MT. POLLEY MINE

N. ROSE GEOTECHNICAL INSPECTION OF OPEN PIT,

WASTE DUMPS AND TAILINGS DAM

JULY 31, 2007

FIG. 1

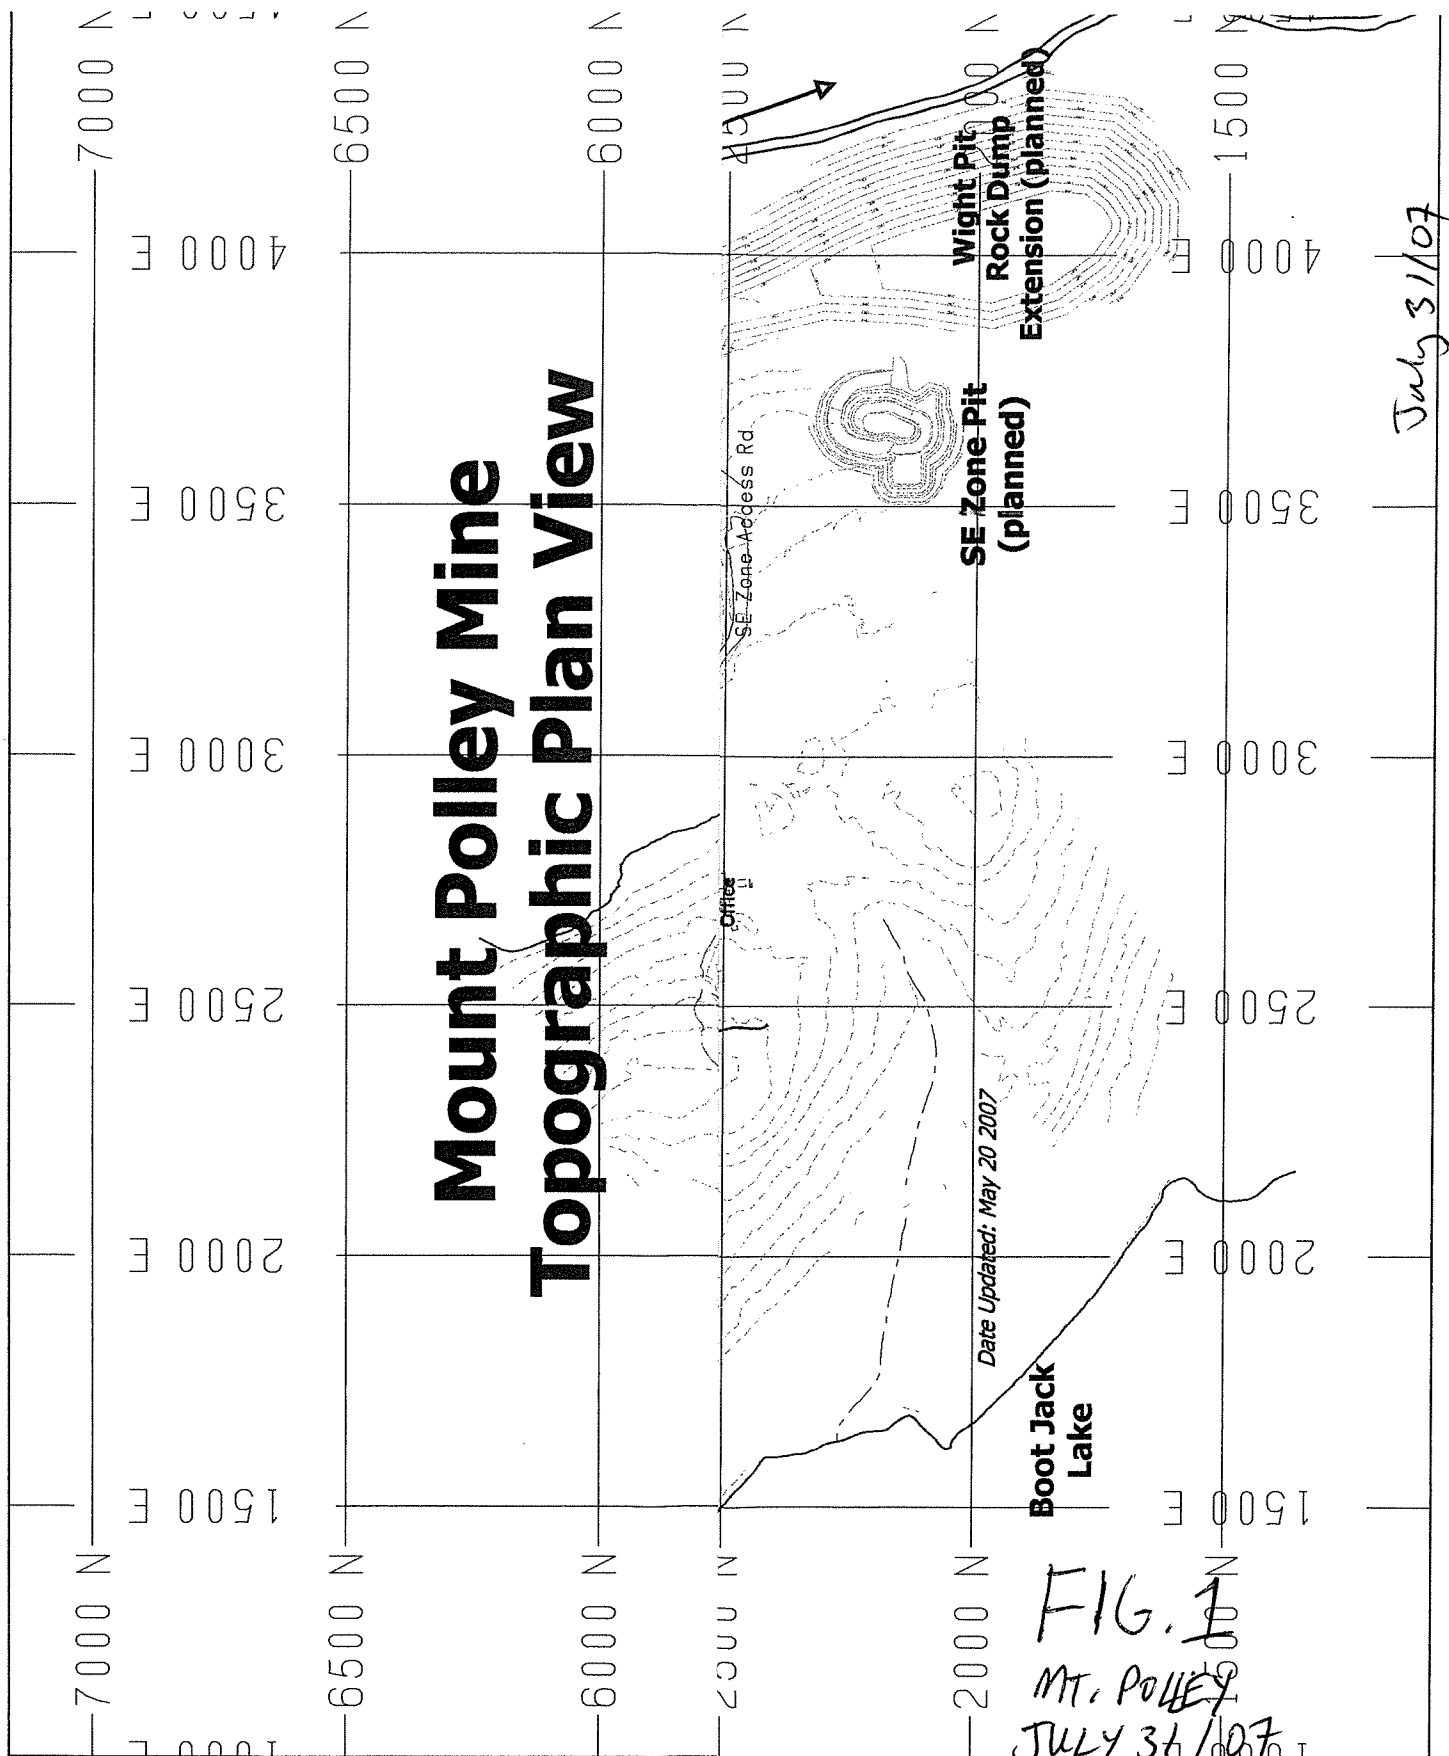
Station 1: Photo of pioneering of upper benches in Springer Pit.

Station 2: Photo of offload cut that was implemented to stabilize slope displacements on west wall (behind east dipping structure observed during last inspection).

Station 3: Inspected area of proposed crest of Springer pit – marked with stakes.

Station 4: Panorama of Bell Pit. Notice northwest dipping structure in west wall and location of southwest offload cut. Previous instability on upper east wall is resulting in filled catch berms. Sloughing on bench above shovel related to steeply dipping north trending fault. **Intermediate west dipping joint set on east wall shall be mapped to determine possible impacts on bench designs. Bench crests shall be scaled with the shovel bucket and toes cleared during excavation to improve catchment for potential rockfalls. Extra precaution shall be taken while operating near the highwall in this area.**

Station 5: The location of the Heap Leach test pad and proposed heap leach pad was inspected. **Baseline monitoring of possible waste dump settlements shall be implemented and provided to the heap leach design consultant.**

Station 6: Photo of East dump toe lifts to flatten overall slope for heap leach construction and to achieve flatter reclamation angle. Panorama of Southeast Zone Pit area from Northeast Dump. Notice new Northeast Zone Dump Extension – stockpiling overburden for reclamation.

Station 7: Photo of TSF haulroad access and access to dump extension. Measured 12° to TSF Haulroad with clinometer.

FIG. 2
MT. POLLEY
JULY 31/07 GEOTECH
INSPECTION
N. ROSE PAEL/MEMPR

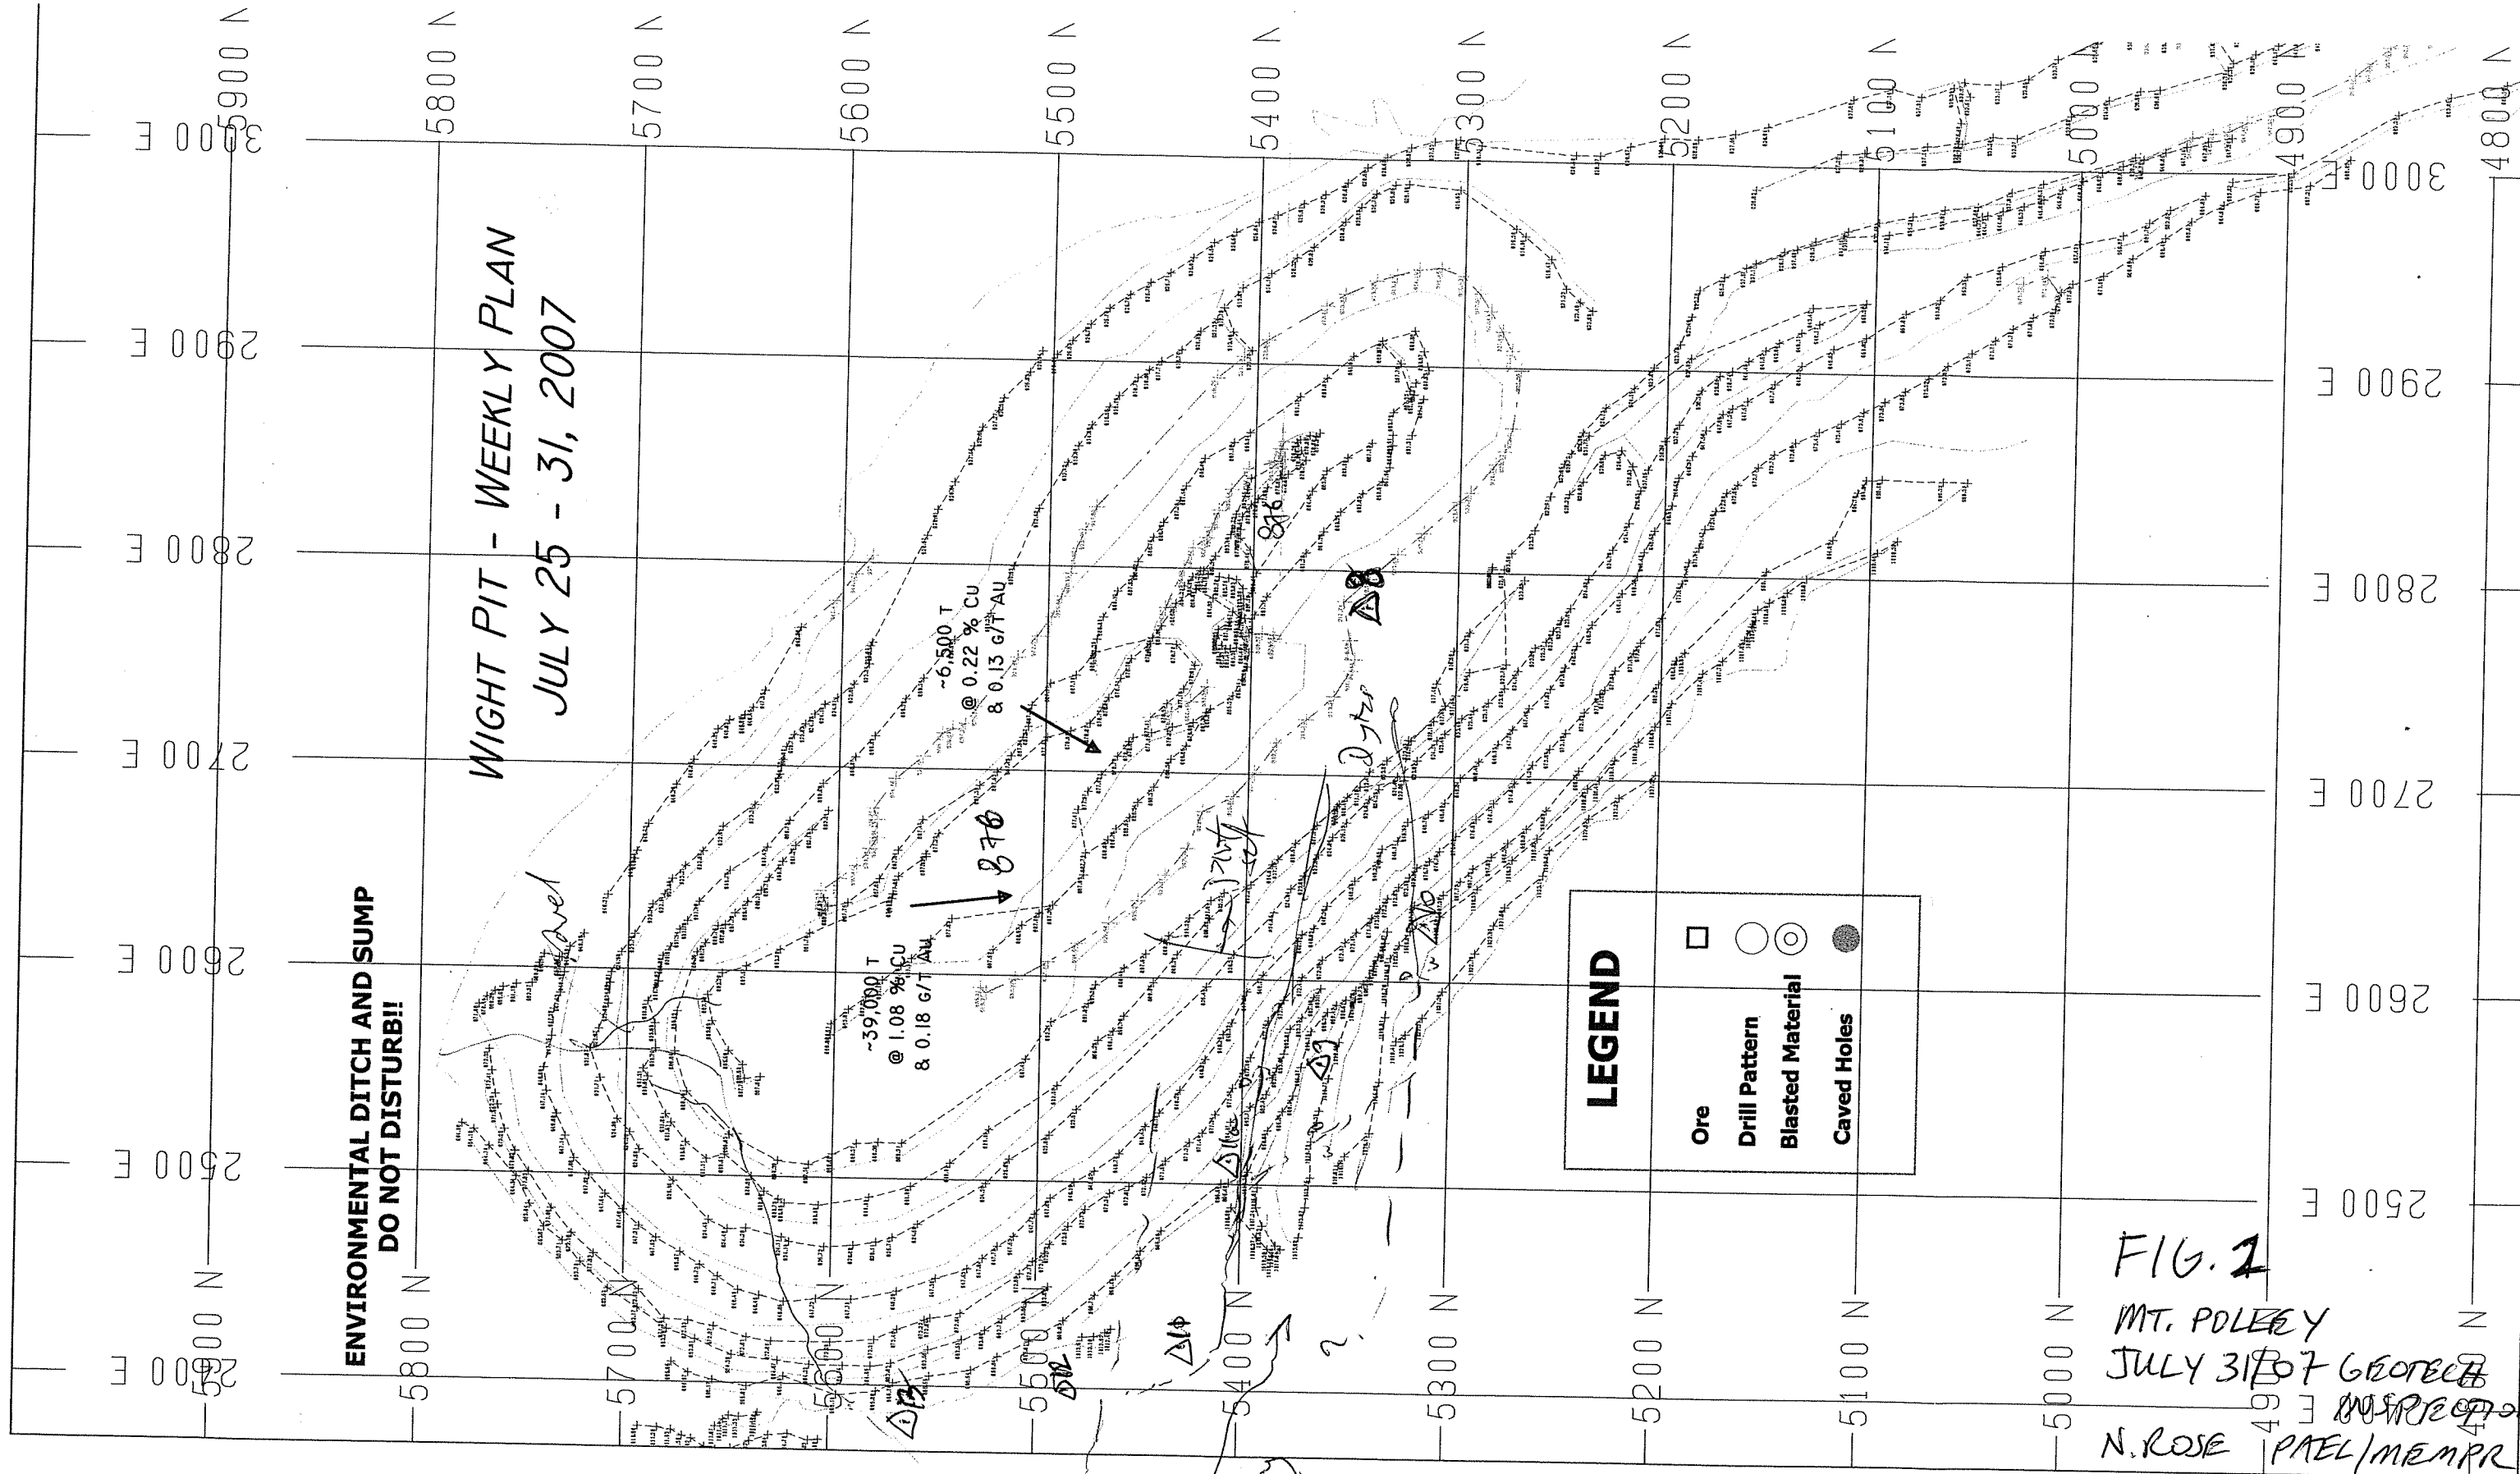
Station 8: Wight Pit: Panorama from 912.5m Level.

- **Need Golder design for final southeast overburden slope.**
- Prisms currently located on 900 and 972m Levels.
- **If safe access available, prism monitoring shall be established on the 924m Bench, north of east-west trending dyke.**
- **Dykes/faults to be located on a map and correlated with area of current instability to determine if additional prism monitoring is required.**
- Seepage noted on southeast wall below current overburden contact.
- southeast pumps on timer, 15 hp and 5 hp pumps. Probes close together to cycle on-off.

Station 9: Wight Pit inspection of west wall pit crest area.

- Major cracks behind pit crest following trend of dykes/faults.
- Need monitoring to delineate bounds of current movement (i.e., prisms located on outside of major structures as well as within).
- The pit crest area shall be inspected regularly for changes in slope conditions.
- Slope monitoring is being conducted daily during mining and is being reviewed weekly by the design consultant.
- Extensometers/crack monitors to be implemented as supplementary means of manual monitoring.
- **Movement rate thresholds and operational response procedures shall be developed for the west wall instability and submitted to the Ministry within 15 days of receipt of this report.**

Station 10: Additional tension cracks observed beyond the limits observed by mine personnel and design consultant. **Crack locations to be surveyed and plotted on a plan map and correlated with faults/dykes. Additional prisms to be located within and outside tension cracks.**

Station 11: Water ditching may be concentrating surface runoff in headscarp area. **Alternate diversion of surface water should be considered.**

Station 12: Approximately 10 to 15cm of downward displacement noticed on east-west trending fault on southern portion of instability.

Station 13: North bounding fault on northwest wall forms dyke on northeast wall – east-west trend.

FIG. 3
MT. POLLEY
JULY 31/07
GEOTECH INSPECTION
N. ROSK ATEL/MEMOR
July 31/07
Geotech Inspection

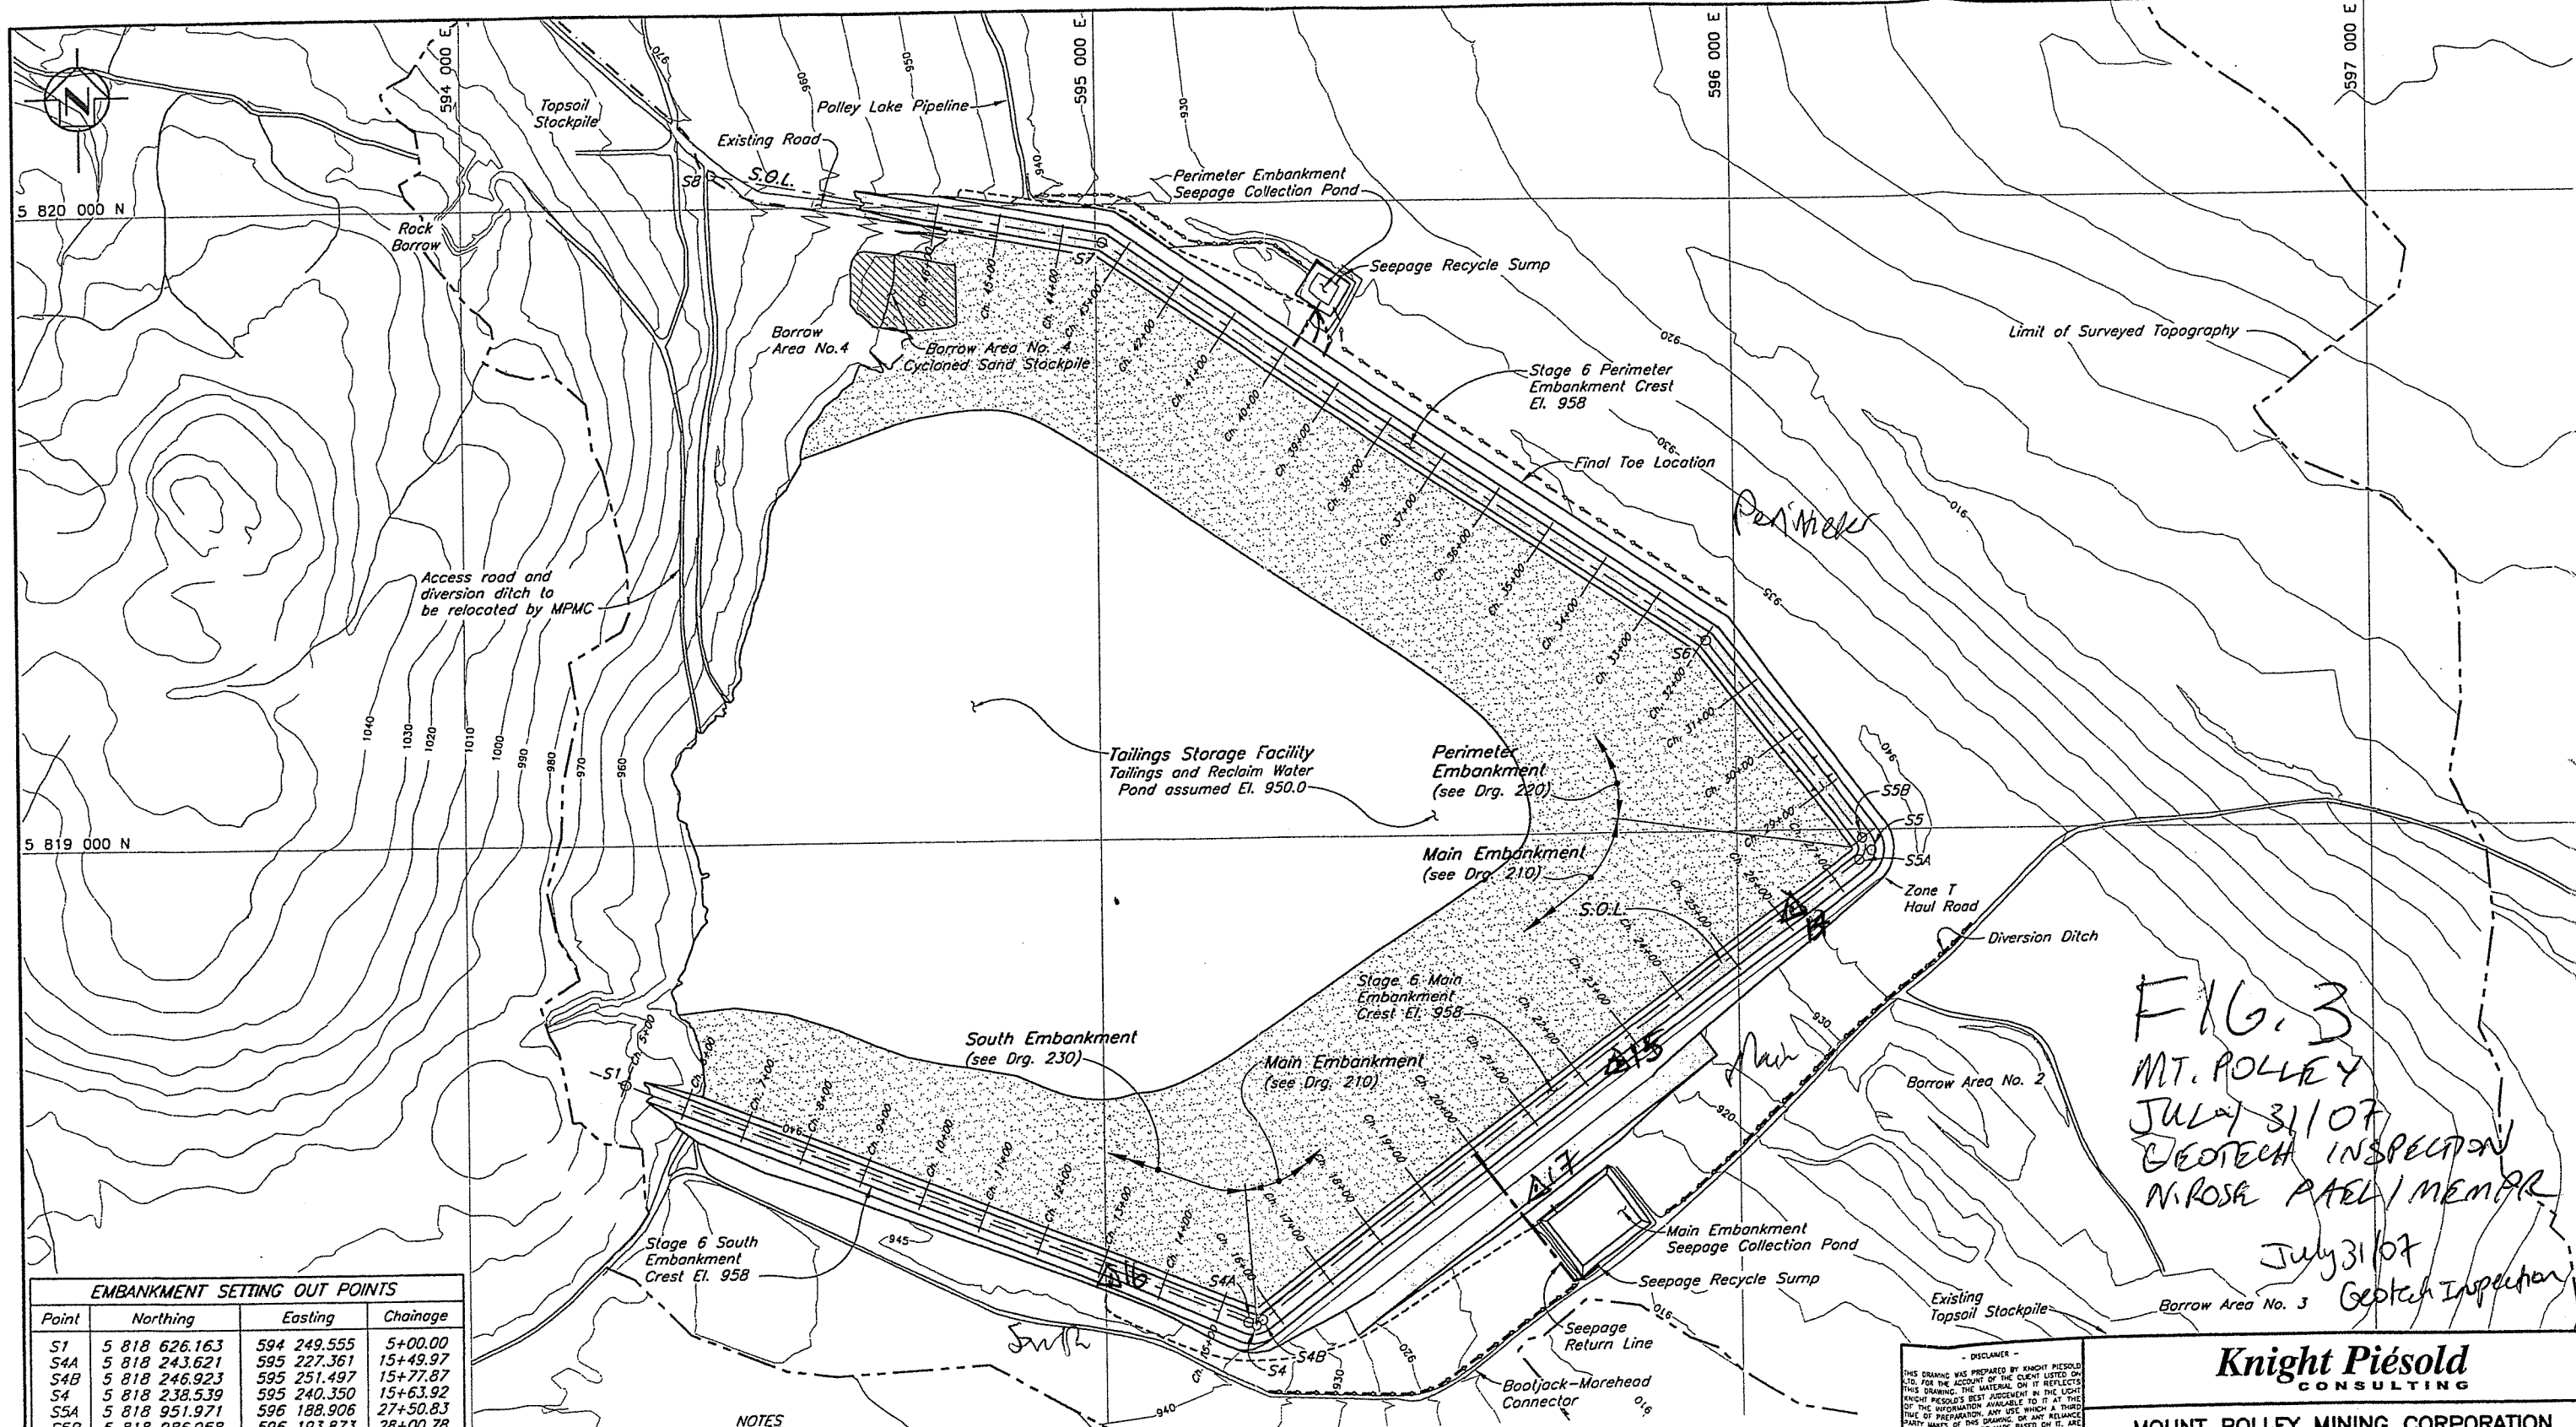
Station 14: Photo of borrow pit area south of TSF. Panorama of Main Dam and impoundment. Upstream (U) Zone, 8m till core zone. Till zone is able to be narrowed to 5m if building all zones simultaneously at same height. This is included in Stage 6 permit application. Main Dam at 950m – to 951m in 6 weeks. Should be able to manage pond levels until next spring at 951m crest.

Station 15: Photo of piezometers on Main embankment.

Station 16: Photo of South embankment – filter and transition zones, compaction.

Station 17: Seepage collection pond at toe of Main Dam. Discharge permit in place, but not discharging to environment.
